SECOND/THIRD READING SUMMARY SHEET

ZONING CASE NUMBER: C14-2009-0079 Austin Hotel Holdings, L.L.C.

ZONING CHANGE REVIEW SHEET

Re: Austin Holdings LLP Hotel project at 201 W. 5th Street

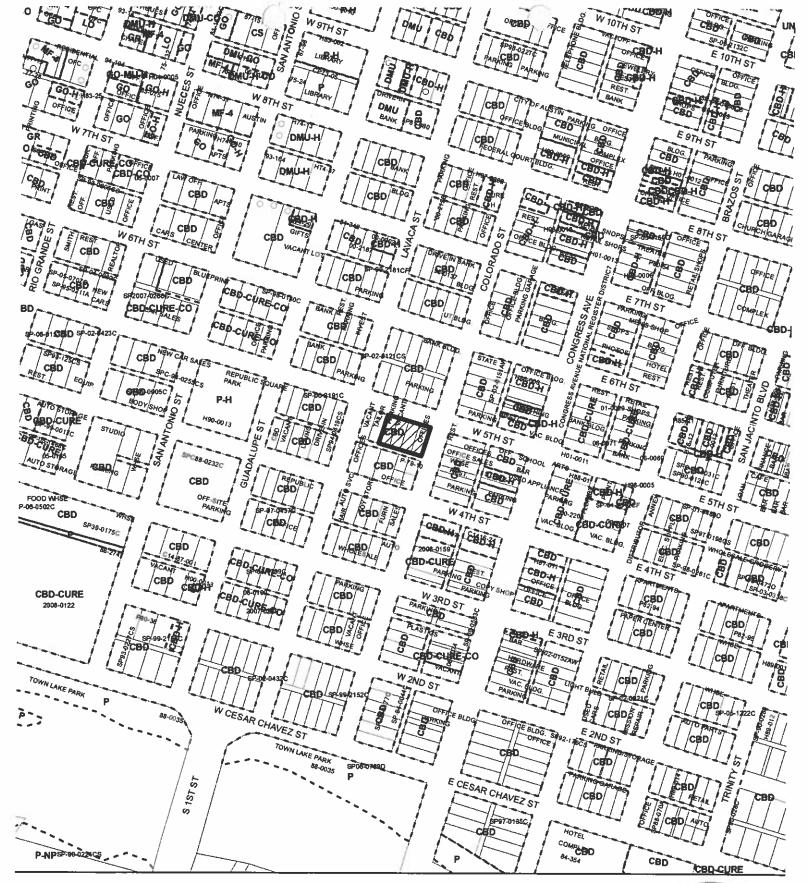
- Step-back on 5th Street and Colorado- The 5th Street elevation was originally presented as
 a 17 story tower flush with the property line with no step-back. The Design Commission
 received a revised sketch (dated 10-23-09) with a 25' tall "Wellness" balcony/setback that
 provides relief between the podium and the tower. The Design Commission supports the
 inclusion of this design component.

- Conflict between Porte Cochere and Pedestrian access-We appreciate that the developer is committed to great streets on the 5th and Colorado portions of the project, however we do want to insure that the pedestrian is the most protected and comfortable traveler along both streets. We therefore request that the material used on the vehicular access portions of the streetscape (on both 5th Street and Colorado) are pedestrian friendly and are designed to make pedestrians the priority. We also request that the project team meet with the Great Streets Coordinator to insure that program guidelines are being met.

- Demolition- While there are no regulations to prohibit demolition of a building immediately prior to commencing new construction, downtown has lost several structures that remain vacant with no immediate redevelopment plans. The Design Commission requests that exterior demolition not take place until the construction schedule has been firmly established.

- Landscape and Streetscape plans- these plans have not yet been fully developed. The Design Commission requests an update once these plans have been articulated.
